UNITED STATES PATENT AND TRADEMARK OFFICE

APPLICATION NO.	FILING DATE	FIRST NAMED INVENTOR	ATTORNEY DOCKET NO.	CONFIRMATION NO.
10/003,404	12/06/2001	Koji Nii	027260-505	5384

Office Action Summary

DETAILED ACTION

FIG. 20

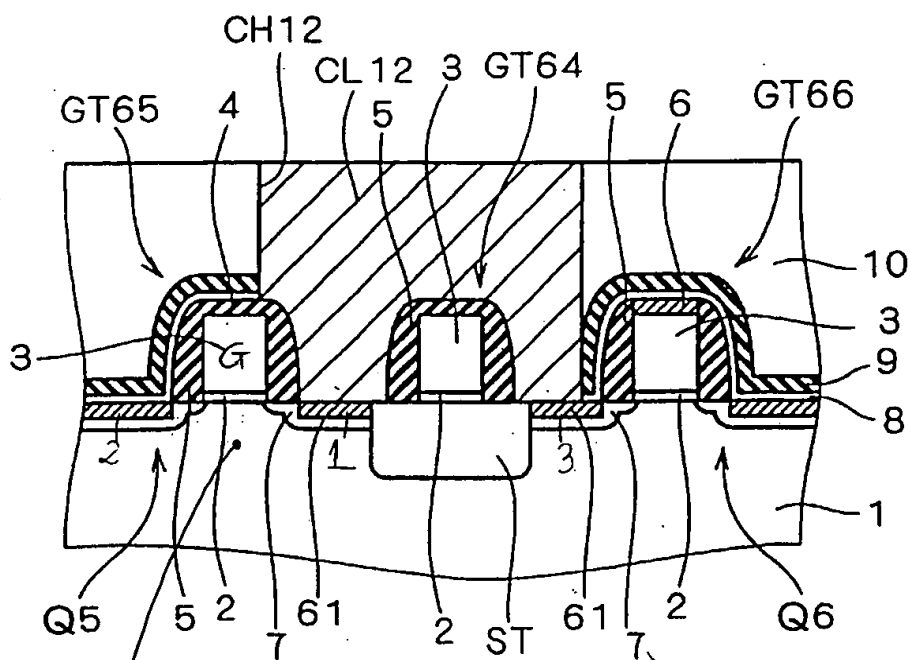
With regard to claims 1,17 Igarashi et al. disclose a gate electrode 3 formed on a substrate 1 through a gate insulating film 2 lying therebetween; first and second diffused layers formed opposite to each other across the portion of the substrate 1 existing under the gate electrode 3 and having a first conduction type, each having a second conduction type different from the first conduction type of the portion; a contact CL12 formed within a contact hole CH12 on the substrate 1. (Note attachment # 1 of Fig. 20 of Igarashi et al.).

With regard to claim 2, Igarashi et al. discloses the contact CL12 is connected also to the second diffused layer. (Note attachment #1 of Fig. 20 of Igarashi et al.).

With regard to claim 3, Igarashi et al. discloses a third diffused layer formed on the substrate 1; and an isolation area ST formed between the first and the third diffused layers, which separates the first and the third diffused layers each other; wherein the contact CL12 is connected further to the third diffused layer. (Note attachment # 2 of Fig. 20 of Igarashi et al.).

With regard to claim 4, Igarashi et al. disclose a gate electrode 3 formed on a substrate 1 through a gate insulating film 2 lying therebetween; a diffused layer formed on the substrate having first and second diffused portions formed opposite to each other across the portion of the substrate 1 existing under the gate electrode 3 and having a first conduction type, each having a second conduction type different from the first conduction type of the portion of the substrate and a third portion that connects the first portion to the second portion; a contact CL12 formed within a contact hole CH12 on the substrate 1, (Note attachment # 2 of Fig. 20 of Igarashi et al.).

With regard to claim 6, Igarashi et al. discloses another diffused layer formed on the substrate 1; and an isolation area ST formed between the first portion of the diffused layer and the another diffused layer, which separates the first portion of the diffused layer and the another diffused layer, wherein the contact is connected further to the another diffused layer. (Note attachment # 2 of Fig. 20 of Igarashi et al.).
